Plotted: 12/09/2025 2:59 PM W:\2025\250438A\CADD\DATA\LANDSCAPE\Map Sheet\Final\LD-1 TREE PRESERVATION PLAN

BLOOMINGTON WORKFORCE APARTMENTS

REAL ESTATE EQUITIES

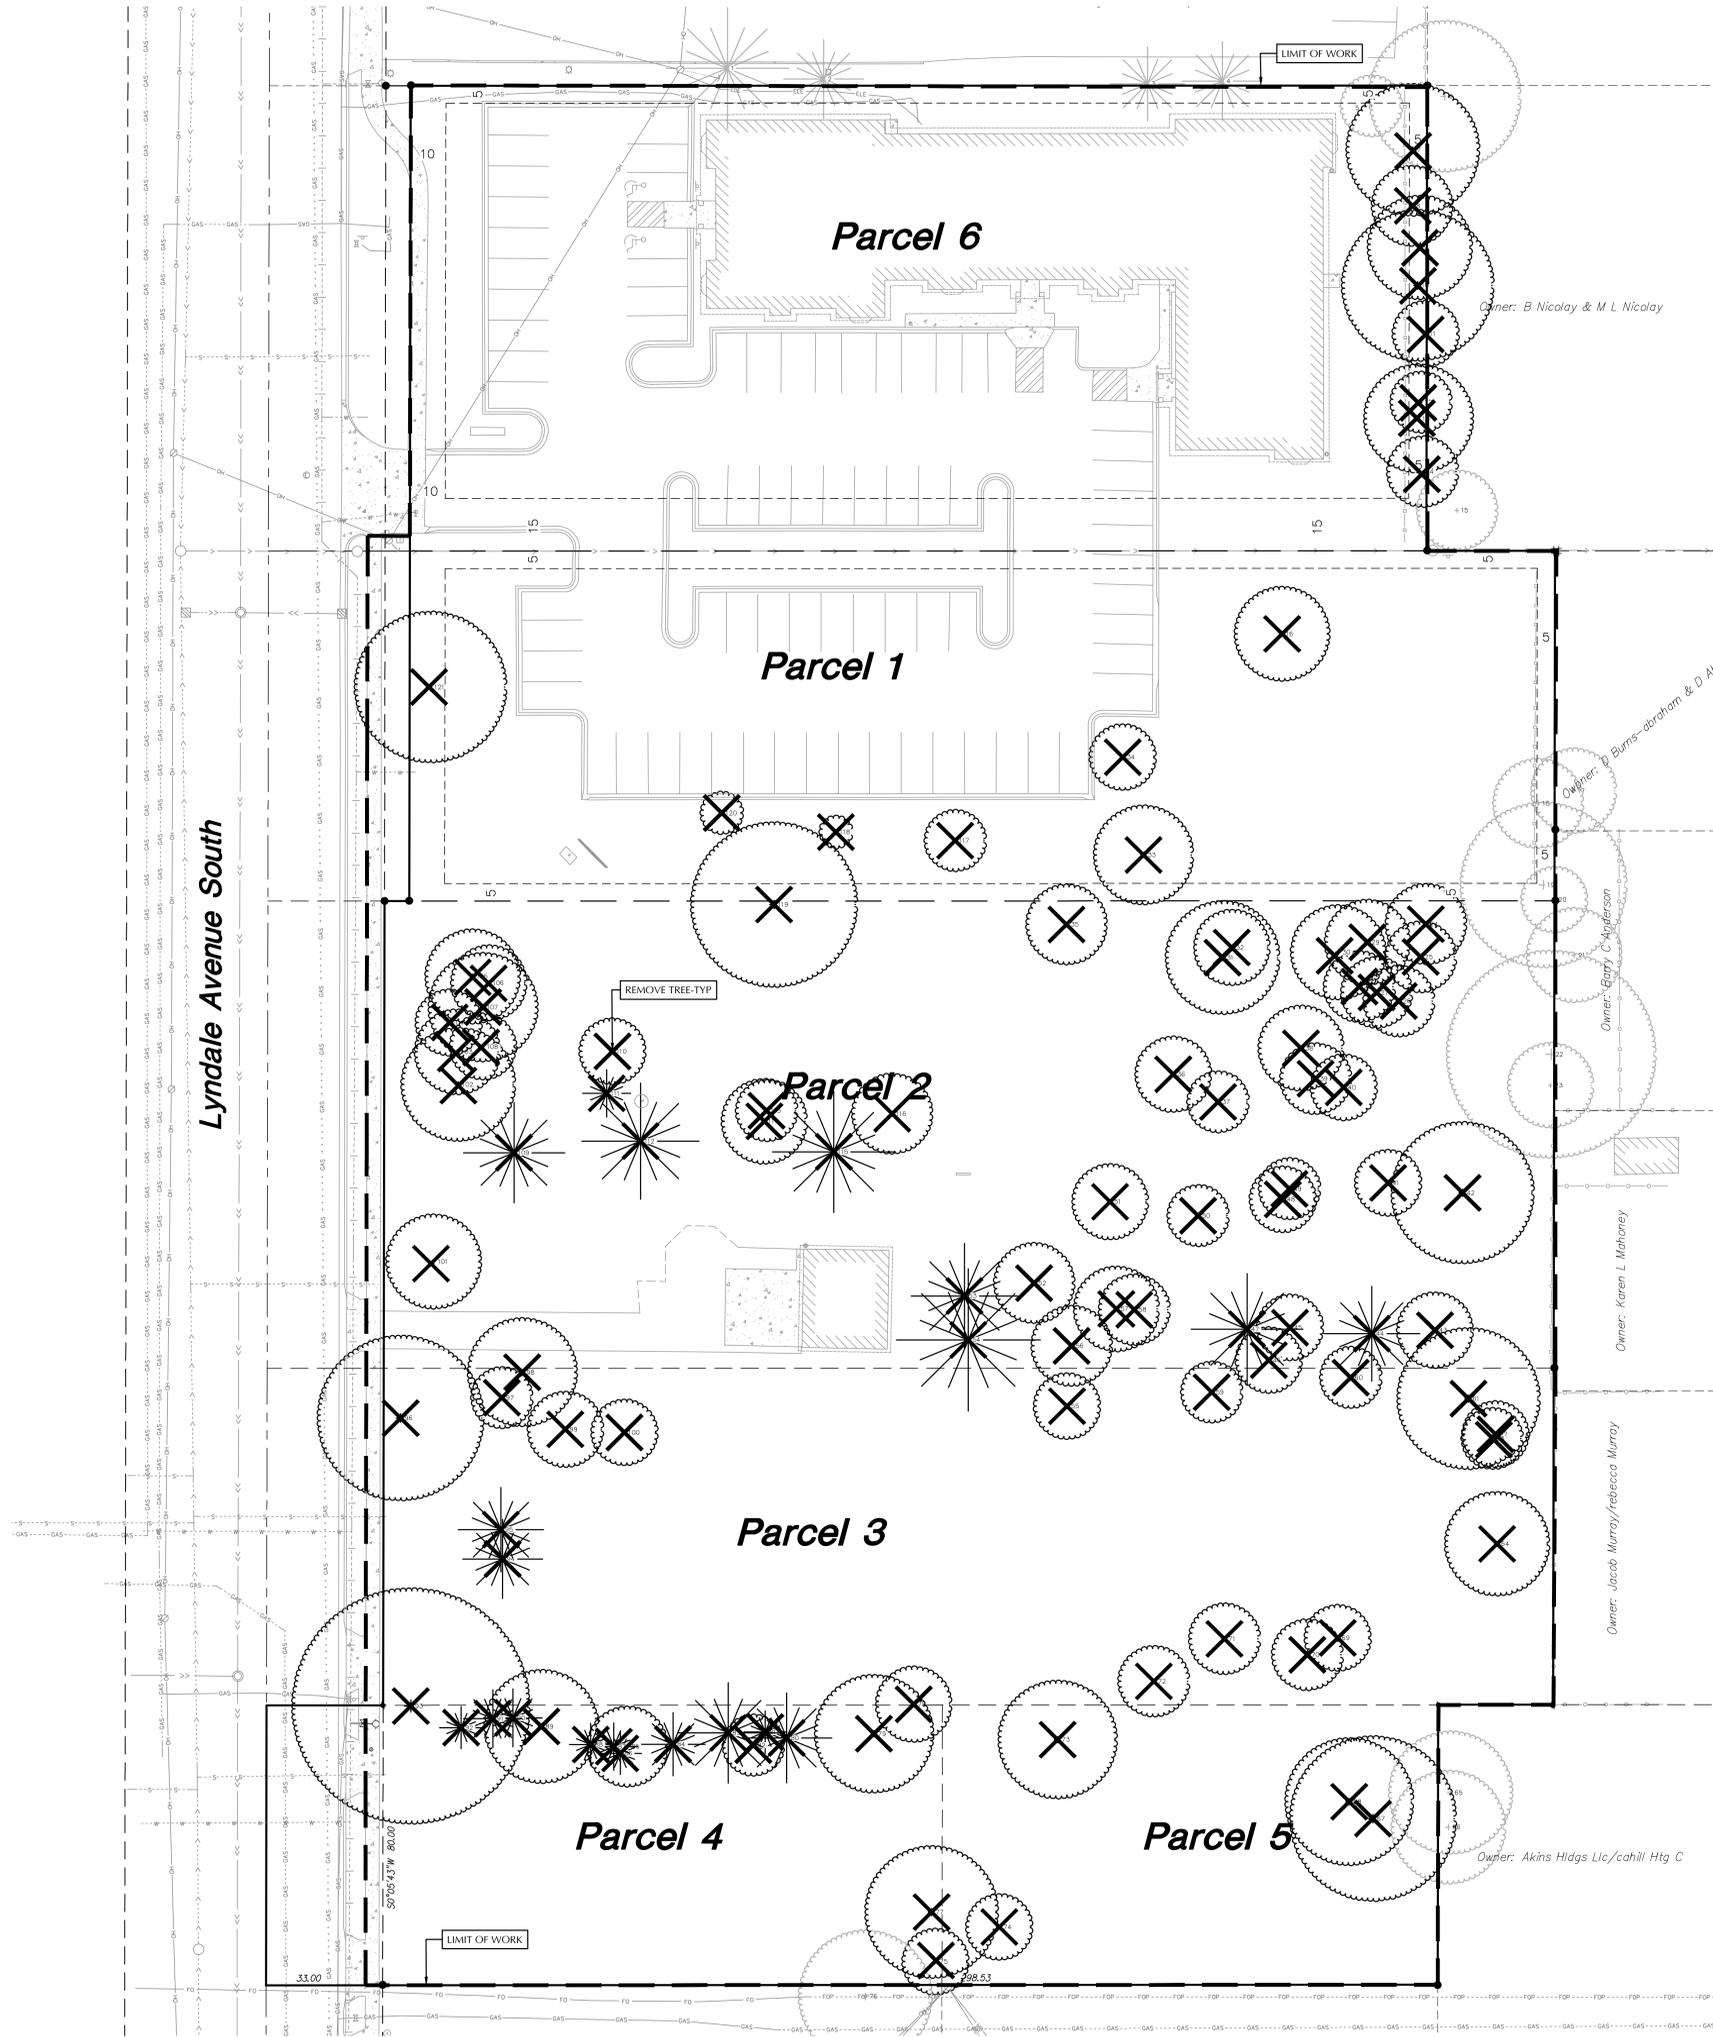
Ensure landscaping doesn't interfere with access to the building, hydrants and/or FDC.
